# Idle Insertion simulation results and state diagram improvements

**Eric Lynskey**  
**IEEE 802.3av Task Force Meeting**  
**July 15-17, 2008**  
**Denver, Colorado**

Figure 1-1—PCS Idle Insertion

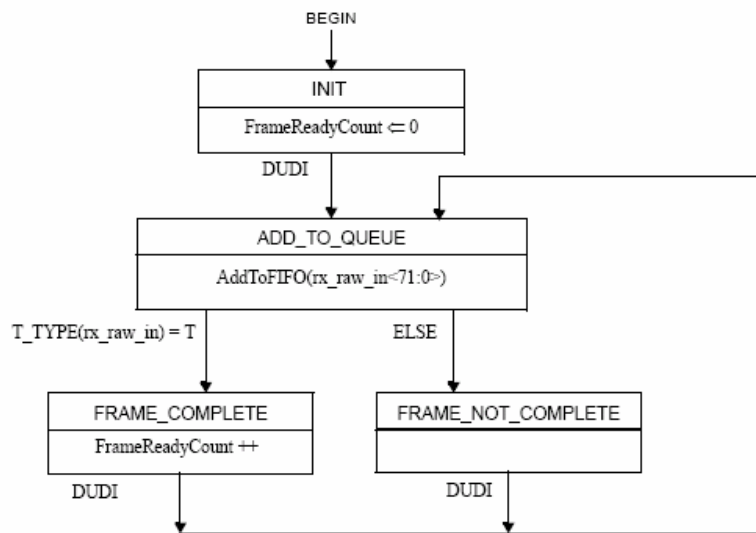
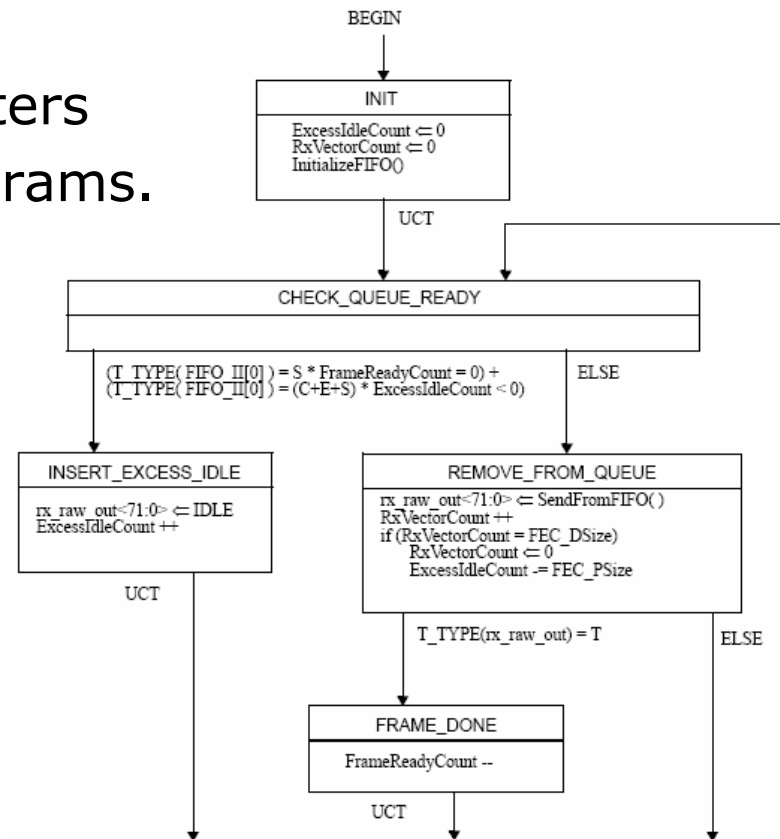
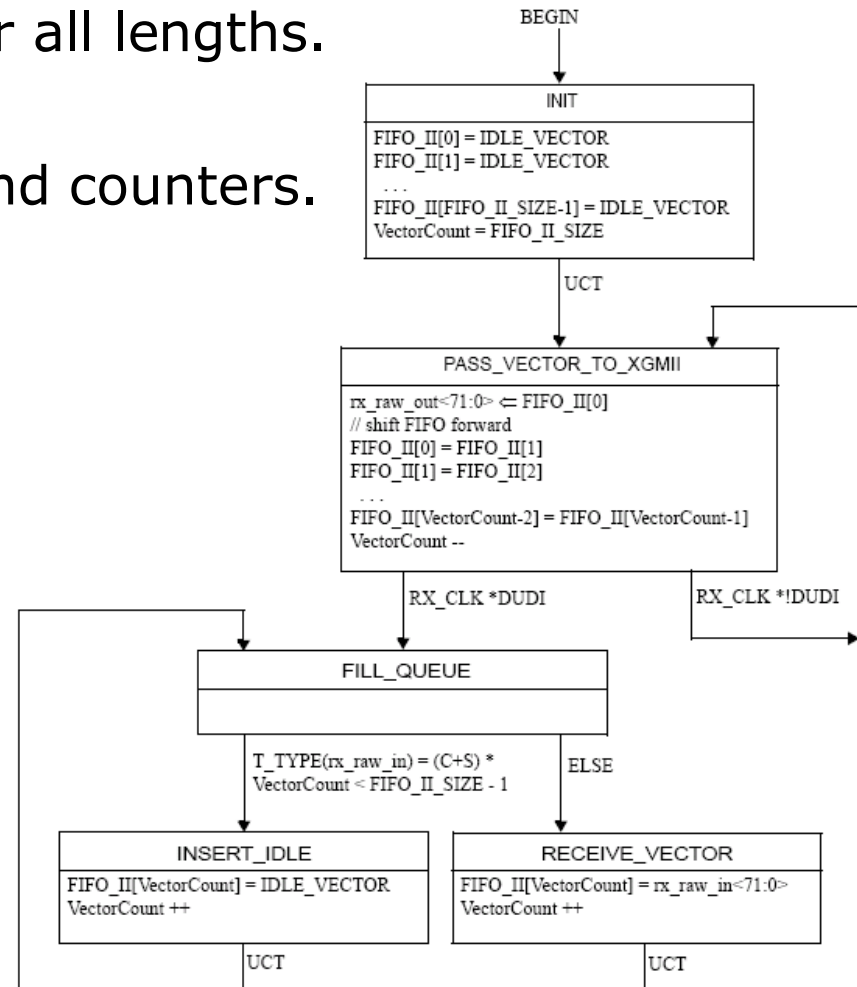
- The existing Idle Insertion mechanism in D1.8022 does not maintain a constant delay.
  - Frames of different lengths experience varying delays.
  - Frames of the same length experience varying delays.
  - Maximum delay variation approaches 70 TQ.
- The delay variation through the PMA and PCS must be kept to no more than 1 TQ.
- For MPCP to function properly the delay variation must be kept below 8 TQ.
- **Idle Insertion state diagram must be updated to reduce delay variation.**

- Large latency variation for different frame lengths.
- Large latency variation for frames of same length.
- Two diagrams with 9 total states.
- Complexity of functions and counters maintained by different state diagrams.

- Figure 92-26 and Figure 92-27 are merged into a single figure with fewer states.
- The following functions are removed:
  - AddToFIFO();
  - InitializeFIFO();
  - SendFromFIFO();
- The following counters are removed:
  - FrameReadyCount
  - ExcessIdleCount

- Constant delay through FIFO for all lengths.
- One diagram with 5 states.
- Reduced number of functions and counters.

- Data rate leaving FIFO is 31 out of 31 XGMII clocks.
- Data rate entering FIFO is 27 out of 31 XGMII clocks.
- A maximum length frame of 2000 bytes can have up to 10 sets of parity inserted. Thus, up to 40 parity vectors can be removed by FEC decoder from one frame. FIFO needs to pre-buffer enough vectors (>40) in order to prevent run.
- General idea: When /S/ block arrives to the FIFO\_II, make sure it sees 40 vectors buffered ahead of it.
- How to do it: At the end of every frame, refill FIFO with IDLE to guarantee that the FIFO has 40 vectors in it.
- No matter what the length of the frame, it will receive a delay of 40 vectors. This corresponds to 16 TQ.

- Simulations show that existing Idle Insertion state diagram can introduce an unacceptable amount of latency variation.
- A new state diagram has been presented.
- Simulations show that proposed Idle Insertion state diagram introduces a fixed amount of latency variation of 16 TQ.
- The Task Force should consider this state diagram as a replacement before heading into Working Group ballot.
